Item Number: 3

1 Stansell Street, Gladesville

Section 4.56 modification to LDA2021/0125 being a Court approved residential flat building development. The application seeks to add a two-storey walk-up unit to the front building, changes to the communal open space area and relocation of services

**City of Ryde
 Local Planning Panel Report**

SOUTH ELEVATION
SCALE 1:200

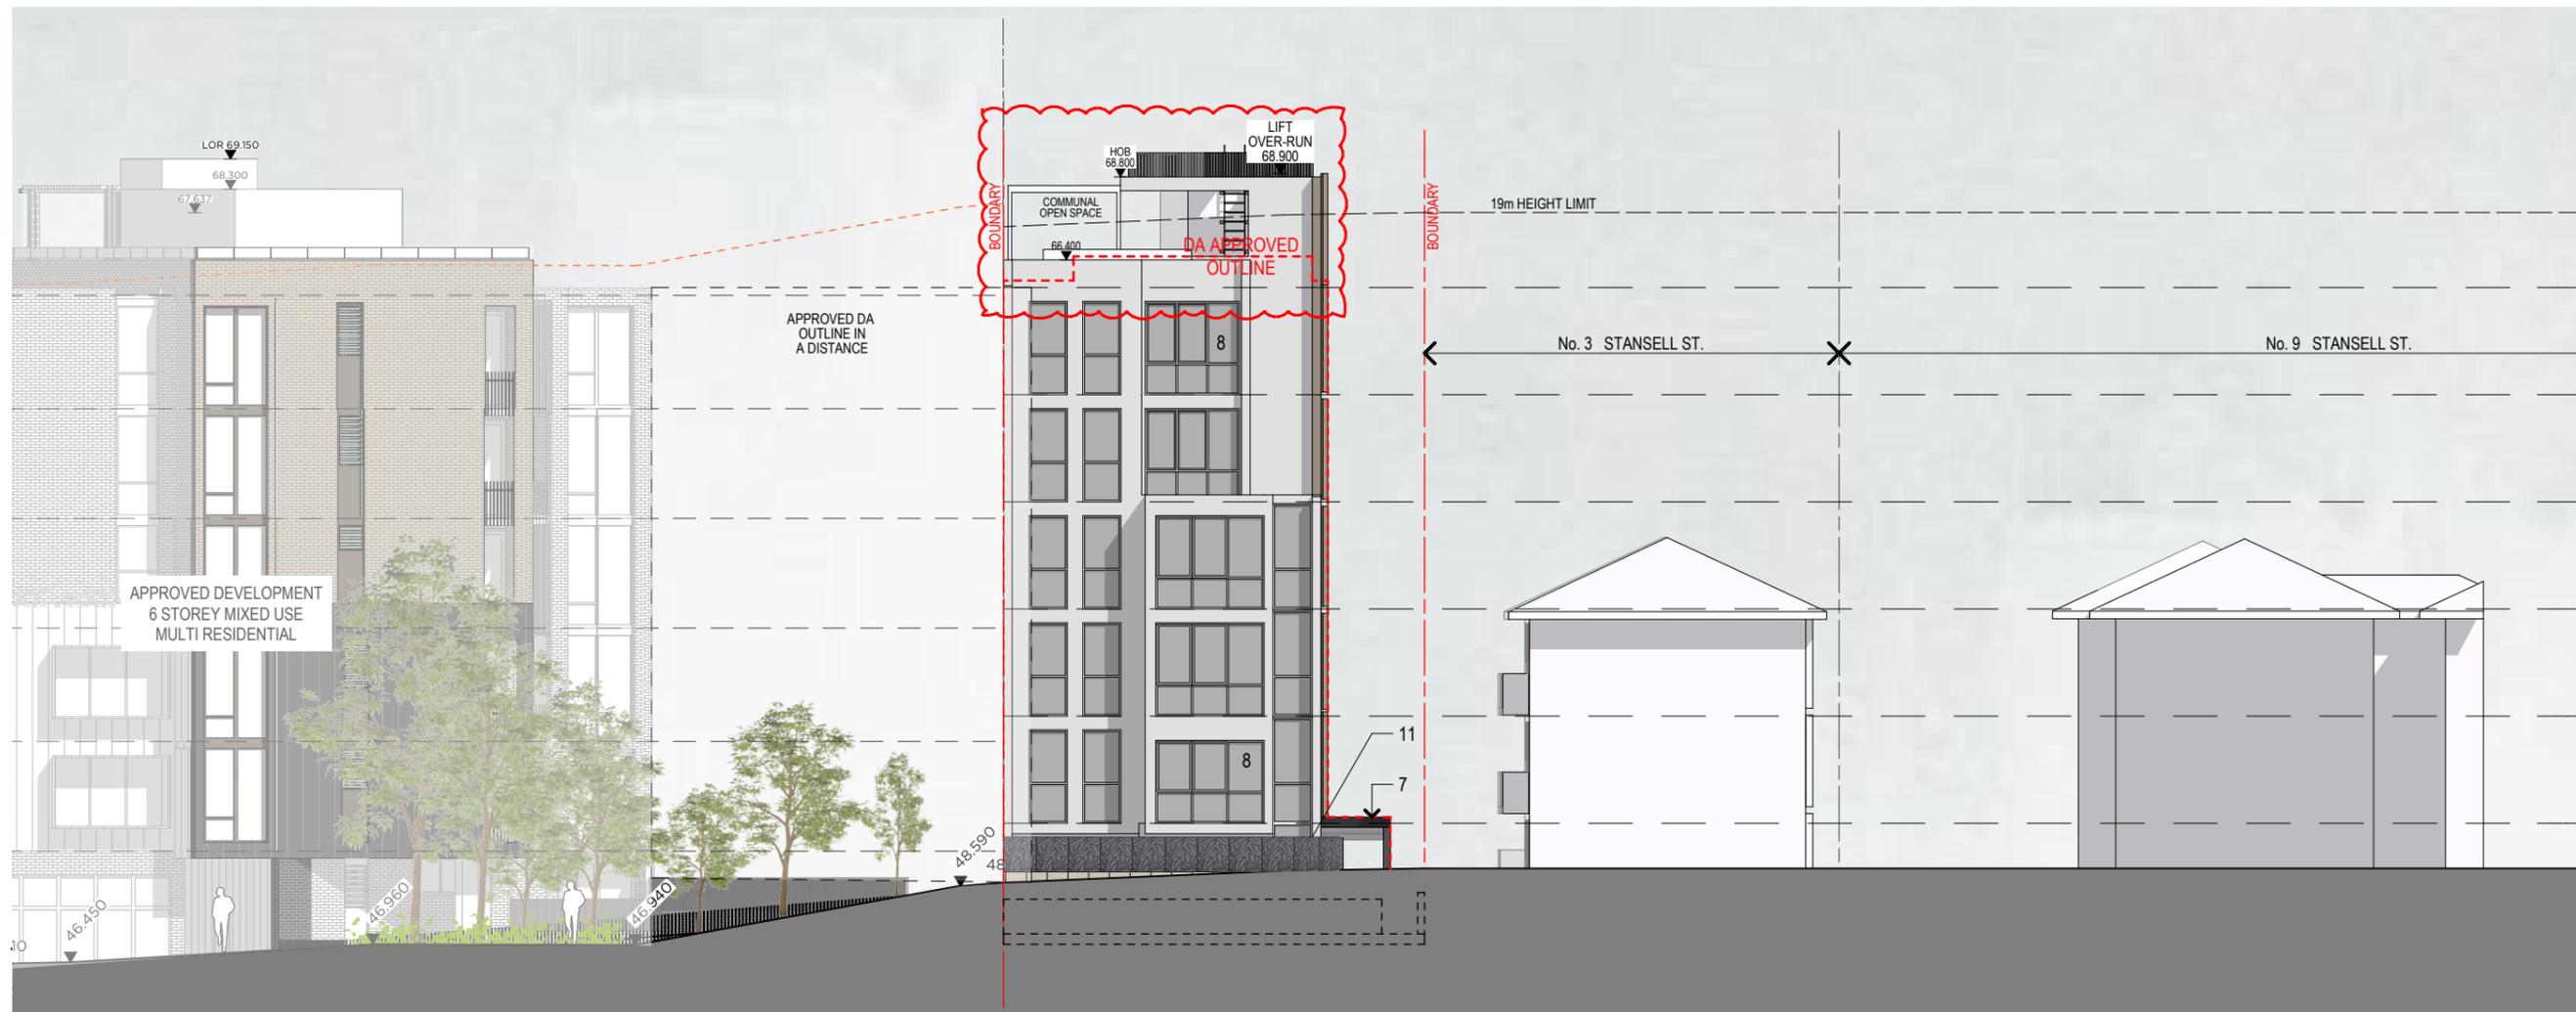
SCHEDULE OF AMENDMENTS
- C.O.S. RELOCATED TO L6

EAST ELEVATION
SCALE 1:200

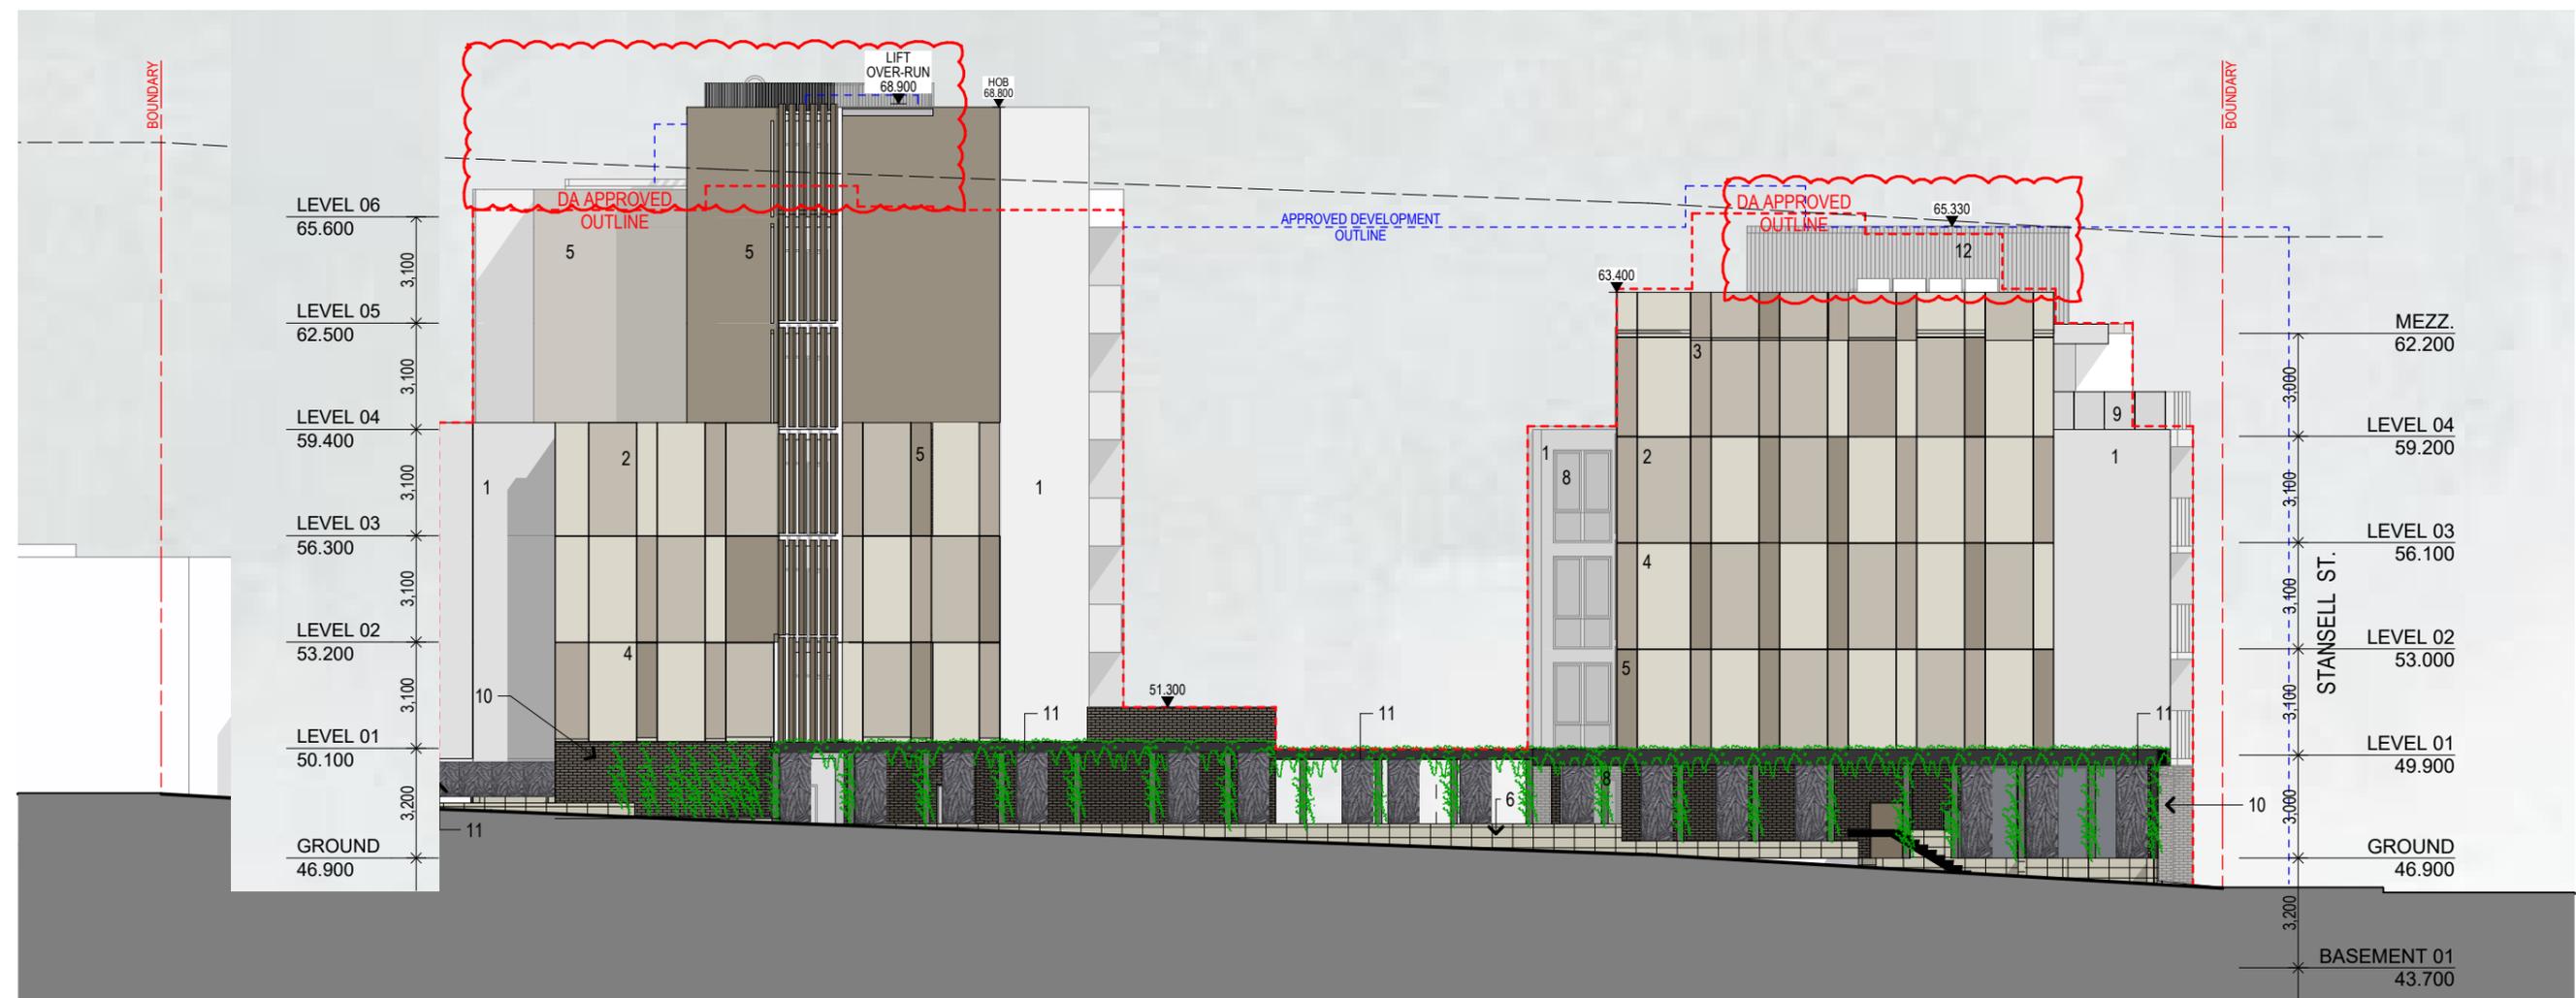
SCHEDULE OF AMENDMENTS
 - UNIT L4.02 REDESIGNED TO A 2 STOREY WALK-UP.
 - C.U. UNITS AWAY FROM THE EDGE
 - C.O.S. RELOCATED TO LEVEL 6

WEST ELEVATION
SCALE 1:200

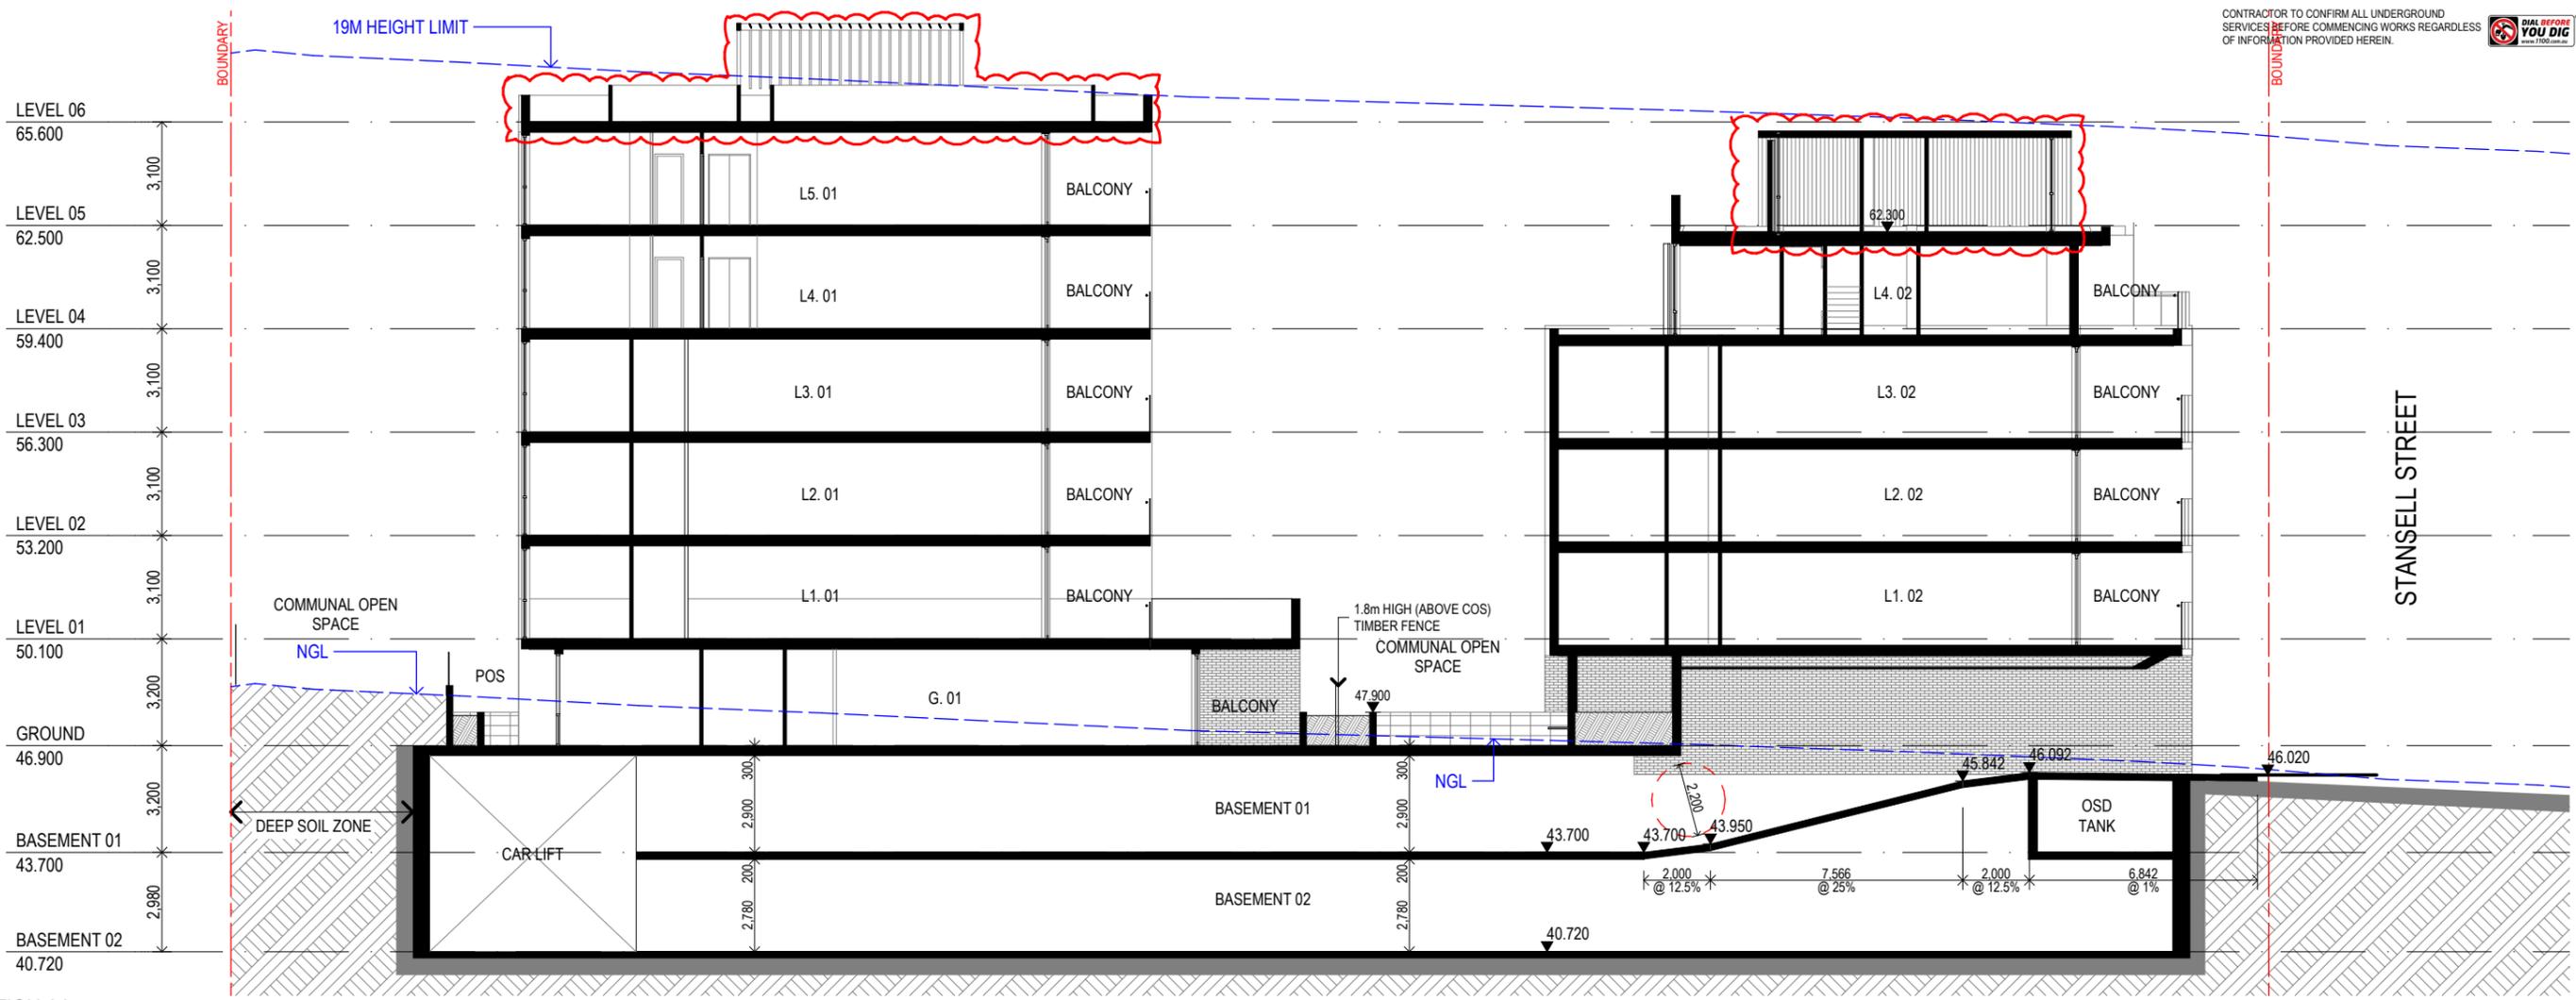
SCHEDULE OF AMENDMENTS
 - UNIT L4.02 REDESIGNED TO A 2 STOREY WALK-UP.
 - C.U. UNITS AWAY FROM THE EDGE
 - C.O.S. RELOCATED TO LEVEL 6

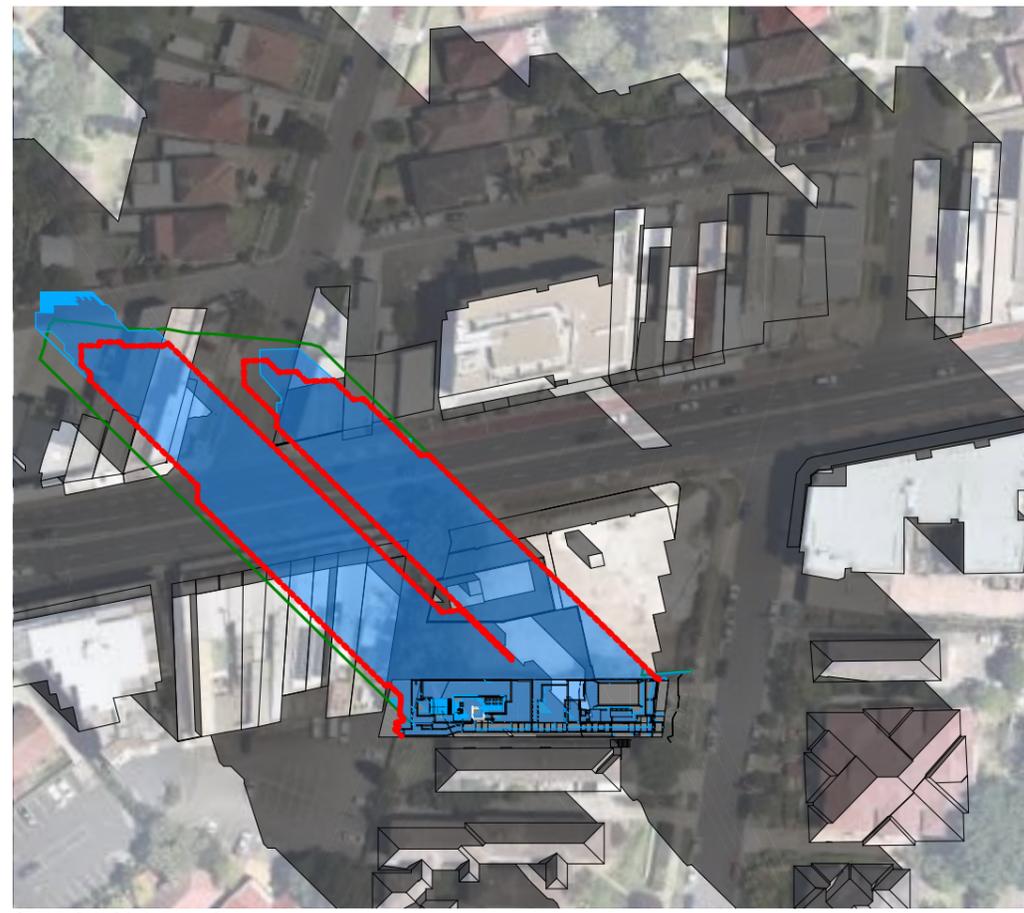
SCHEDULE OF AMENDMENTS
- GFA AMENDED ON LEVEL 4,5&6
